Memorandum

Zayibeth Carballo
Township of West Orange, Department of Engineering
25 Lakeside Avenue
West Orange, NJ 07052

40-42 Eagle Ridge Way
Block 106, Lots 20.03 & 24.01
Township of West Orange, Essex County, NJ 07052
Project No. 24006174A

Figure 1: 36" Elliptical Outfall per Omland and Osterkorn Interim As-Built Plan

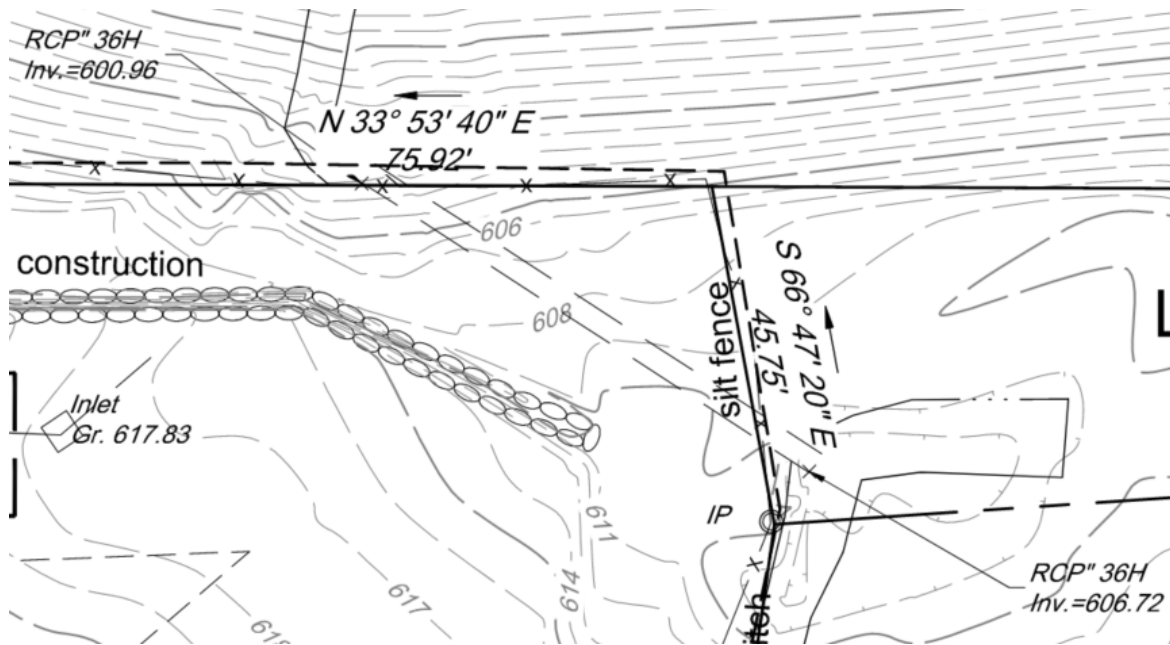
1. The previously used verbiage including “temporary/emergency construction allowance” and “potentially hazardous conditions”, appears to have caused a negative reaction from the Township. That was not the intent. The immediate or emergency concerns pertain to the newly installed 36” wide elliptical RCP storm pipe at the outfall of the existing drainage channel which we understand has been the source of concerns by the Township and the adjoining neighbors. Site inspection photos of a 36” elliptical RCP storm pipe can be seen below, along with Omland & Osterkorn’s survey of the As-Built conditions showing the 36” elliptical RCP pipe and associated elevations. Based on conversations and correspondence with the applicant, there was a directive by the Hudson Essex Passaic Soil Conservation District (HEPSCD) to clean and maintain the existing drainage channel that traverses 40 and

42 Eagle Ridge Way. When the contractor was responding to the HEP SCD directive, he encountered two (2) 12" collapsed clay pipes at the outfall. The intention was to repair and improve this item as part of the cleaning and repair process, not to increase velocity existing at the outfall. The contractor believed that a flatter and wider pipe with a larger surface area should diminish the flow compared to dual 12-inch pipes.

Figure 4: Proposed OCS Location

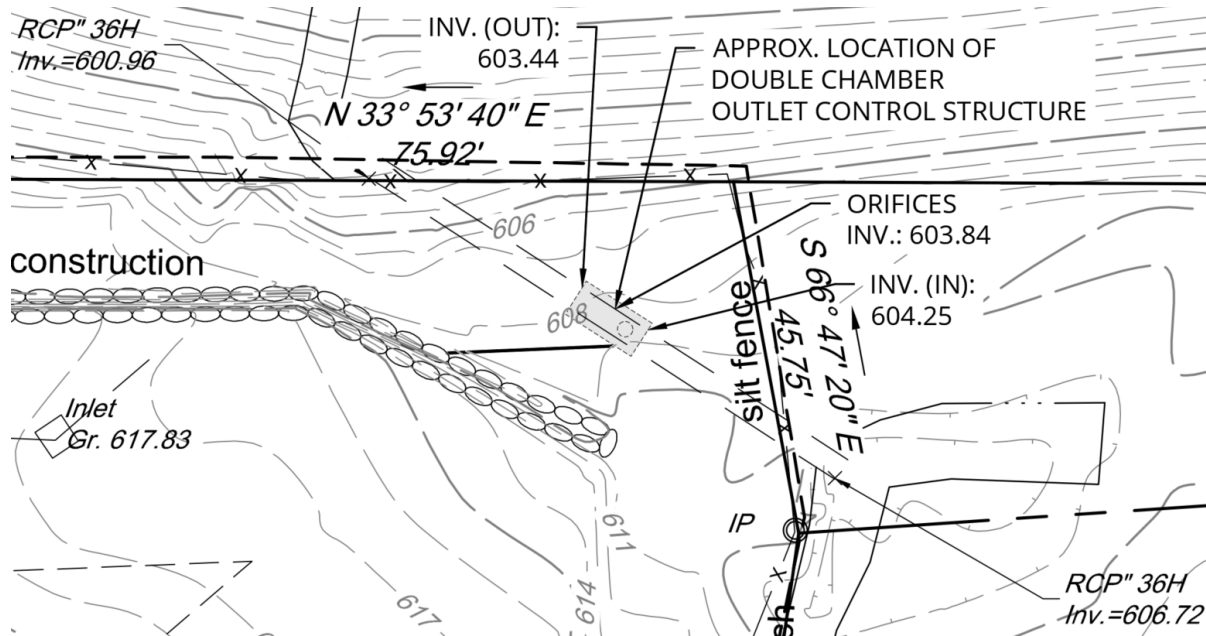
While we believe that imposing obligations on the association to comply with the Resolution remains within the Township's authority and may be part of the Township's long-range plans to improve the storm drainage conditions in Llewellyn Park, we nevertheless considered what the owner of 40 Eagle Ridge Way may do to help alleviate this situation. That is why we propose an Outlet Control Structure (OCS) to reduce the downstream flow in a manner that will work to both reduce the flow of stormwater from the pre-existing damaged dual 12" pipes and act as a collector to assure that only rainwater falls down the mountain slope and not debris or trash.

Figure 5: OCS Design Detail

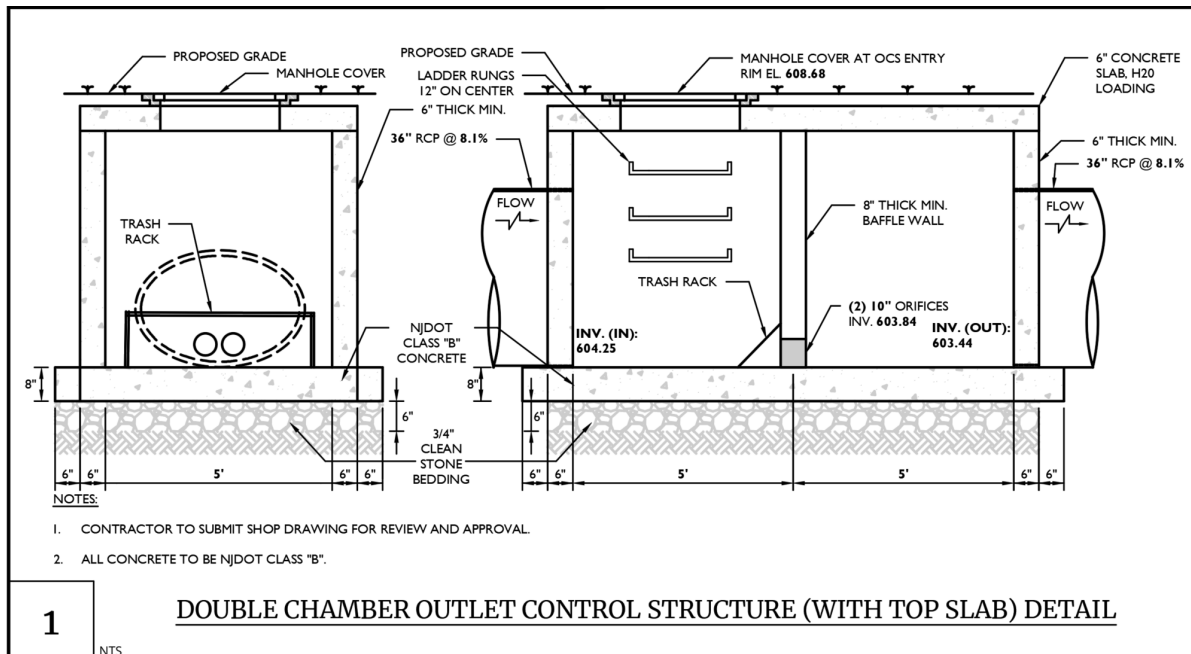
The OCS will be located at the midpoint of the 36" RCP pipe and will contain two (2) 10" orifices that will restrict the flow through the existing 36" elliptical RCP pipe outflow. The below table summarizes the existing and proposed peak flows and peak velocities through the pipes.

Figure 7: Current Wall Conditions per Omland and Osterkorn Interim As-Built

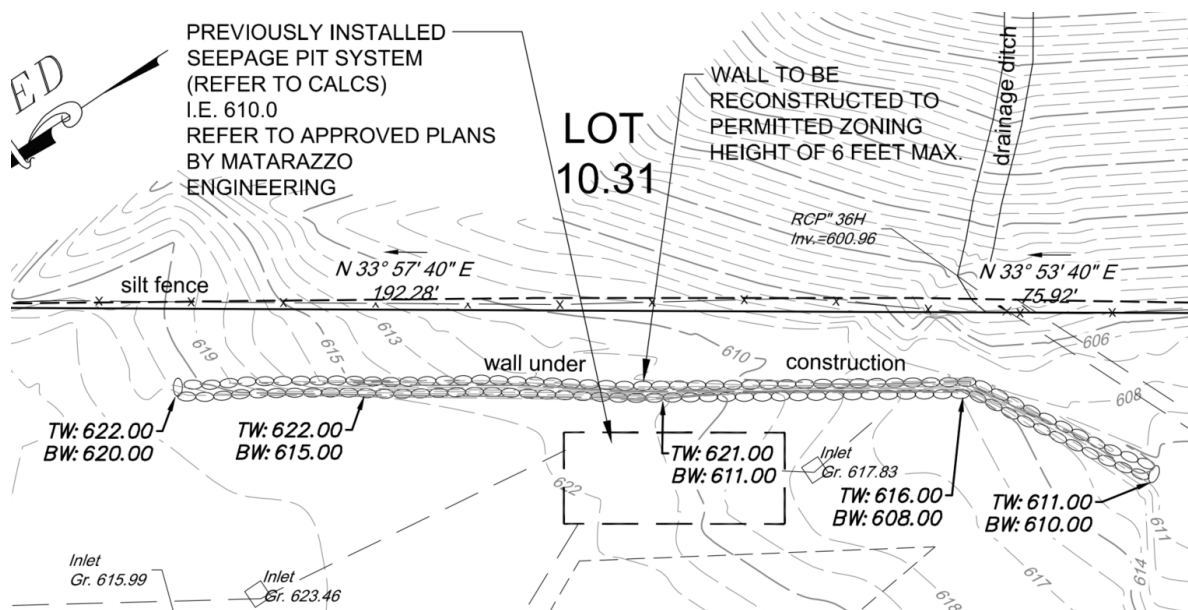
Another item of concern that we feel requires immediate attention is the completion of the stone retaining wall. Based on correspondence and conversations with the owner it is our understanding that the top layers of stone are temporary and intended to be removed with the restoration of the adjacent grades. We learned that the site contractor overcompensated to contain the site drainage to assure that there was no stormwater runoff from the area under construction. Once the construction was completed, the temporary part of the wall was to be removed and the grades restored. The below site photo shows that the top 4-6 feet of the wall is not mortared. When the temporary top courses are removed the grading on both sides will be restored and compacted in accordance with industry standards. The foundation of the wall will be buried, and the final wall from foundation to top will have a maximum height of 6' in limited areas and the height sloped off as intended.

Figure 9: Conceptual Grading Design

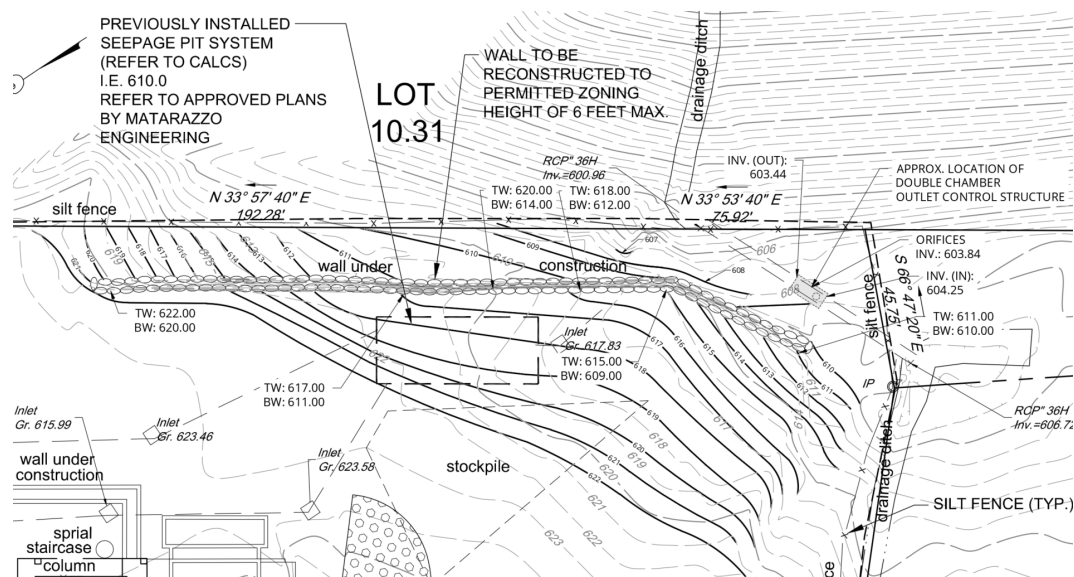
Again, due to heavy rainfall and thunderstorms, the 15' buffer between the east side of the wall and the downstream property line, should be restored to grade, along with addition of crushed stone, thereby removing the potential for erosion. This cannot be done unless the contractor simultaneously removes the top temporary portion of the retaining wall, which will then result in the wall complying with the allowable height. Colliers recommends a full-time inspector from our office be on site to ensure proper construction means and methods are followed, and an additional interim as-built be performed to confirm the finished wall doesn't exceed 6' in any area and that it conforms to the Matarazzo plans submitted to the Township.
